Design Review Subcommittee (DRSC)

Meeting Date: September 9, 2015

SUBJECT: **MCUP 15-111 / MCHP 15-112, Tamarindo Restaurant**, a request to consider the remodel of a one-story commercial building and beer and wine for two future restaurant uses at 108-110 South El Camino Real.

Table 1 - DRSC concerns and project modifications

ATTACHMENT G

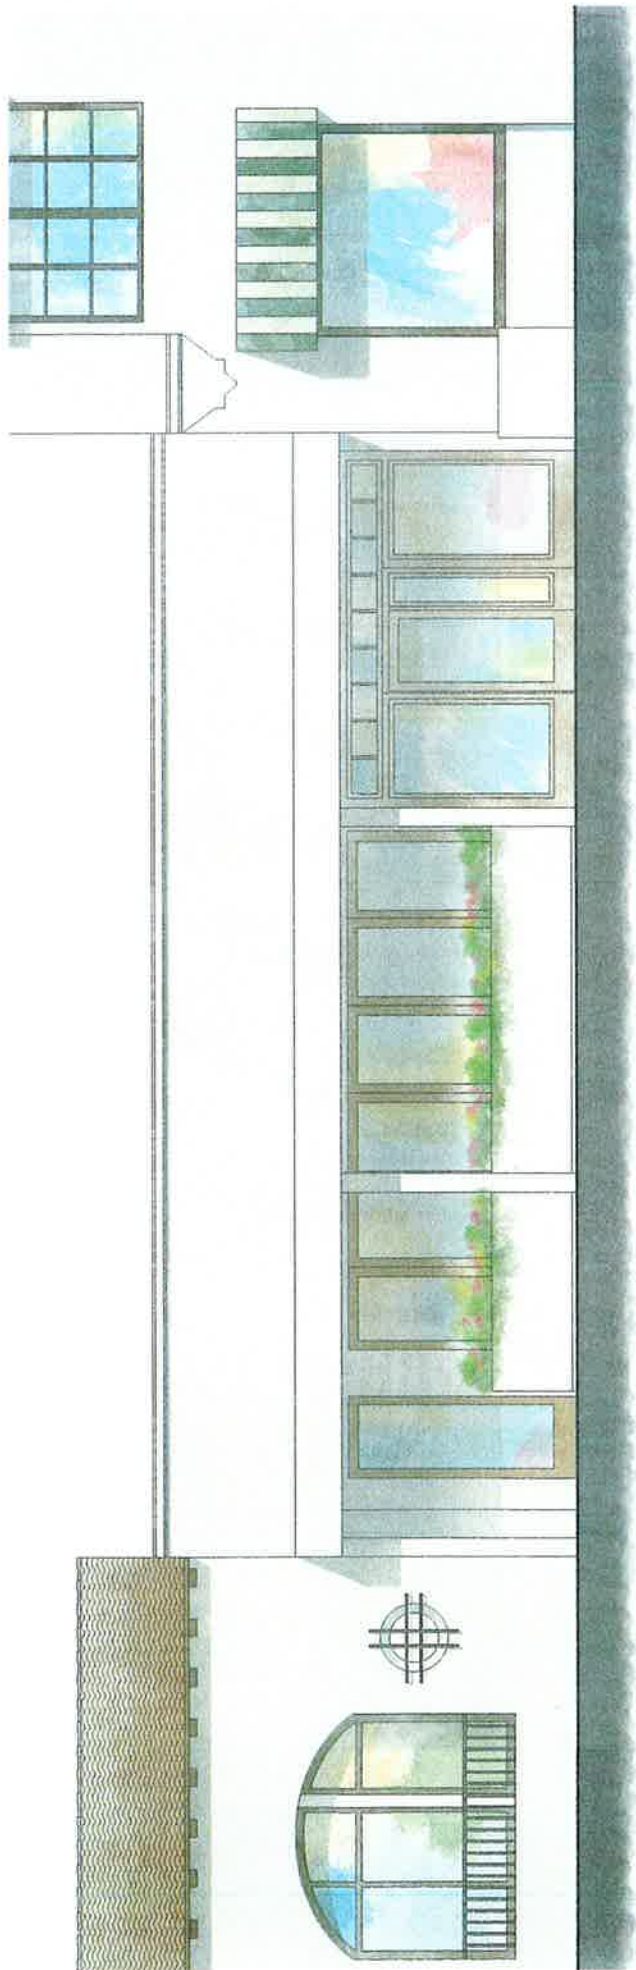
3. Wood doors/windows should be provided along the front elevation and they should have lites. Steel door and aluminum windows at the rear are acceptable provided their finish and detailing is consistent with a wood door/window. Steel door and aluminum windows should have traditional profiles and recessed. Aluminum windows should have lites. The bi-folding doors do not need to have lites.	<i>Modified as requested.</i> Wood doors/windows are proposed along the front elevation. Lites have been added to the west storefront. The aluminum windows at the rear now include lites and are recessed six inches. The steel door is recessed six inches.

[REVISED] STOREFRONT ENTRY TO BE RECESSED
